### **PRE-APPLICATION CONFERENCE**

#### **Sunrise Terrace Subdivision** (2014-003-PAC)

Meeting to be conducted on Thursday January 8, 2015 – 10:00 AM

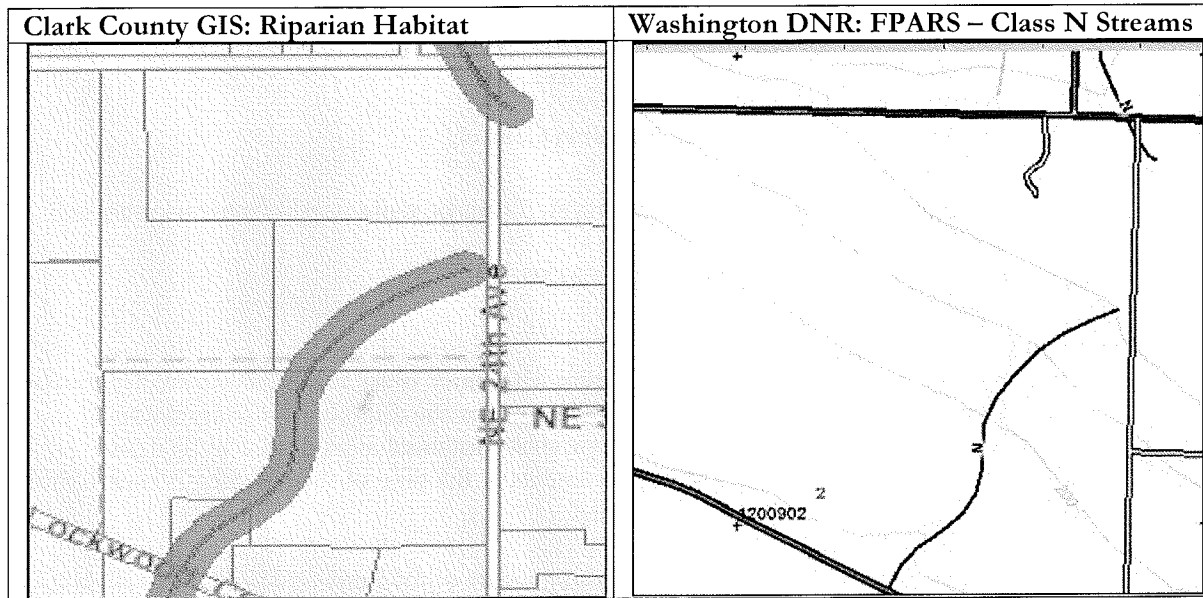
Department Natural Resources FPARS web site indicates a class N seasonal stream that traverses the southeast corner and northeast corner of tax lot 98027-189

Clark County GIS indicates a mapped National Wetland Inventory (NWI) and the presence of hydric soils (Odne) on tax lot 986027-189.

The applicant provided a “Preliminary Wetland Assessment” prepared by Cascadia Ecological Services, Inc. (Cascadia) dated October 14, 2014. Cascadia conducted wetland assessments and soil sampling in the mapped NWI wetlands and Odne soils. Cascadia concluded that based on field sampling and observations of “upland soils, lack of hydrophytic vegetation, and hydrology indicators, the property does not contain any City of La Center regulated wetlands ...”.

Cascadia reports the “presence of a “large drainage ditch” along the south boundary of Tax lot 986027-179. In places “the ditch is in excess of six feet deep”. Cascadia concluded the ditch does not contain indicators of wetland hydrology and that it “likely conveys seasonal stormwater from the east rather quickly through the study area given the relatively consistent slope from east to west.”

Cascadia’s assessment of the “ditch” is consistent with that of a seasonal stream Cascadia did not address the possible Class N stream at the northeast corner of tax lot 98027-179. Type Np streams with low mass wasting potential and less than 3 feet in width on average require a 150-foot buffer. Type Ns streams with high mass wasting potential within a defined channel require a 75-foot buffer. LCMC Table 18.300.090(2)(f) – Riparian Areas. A complete applicant must include an assessment of the quality and function of both Class N streams.

Private improvements in critical areas are not permitted. Pervious trails and public facilities and services may be placed in critical areas and buffers. LCMC 18.300.050. **Platting lots in critical areas, such as riparian buffers is strongly discouraged.**
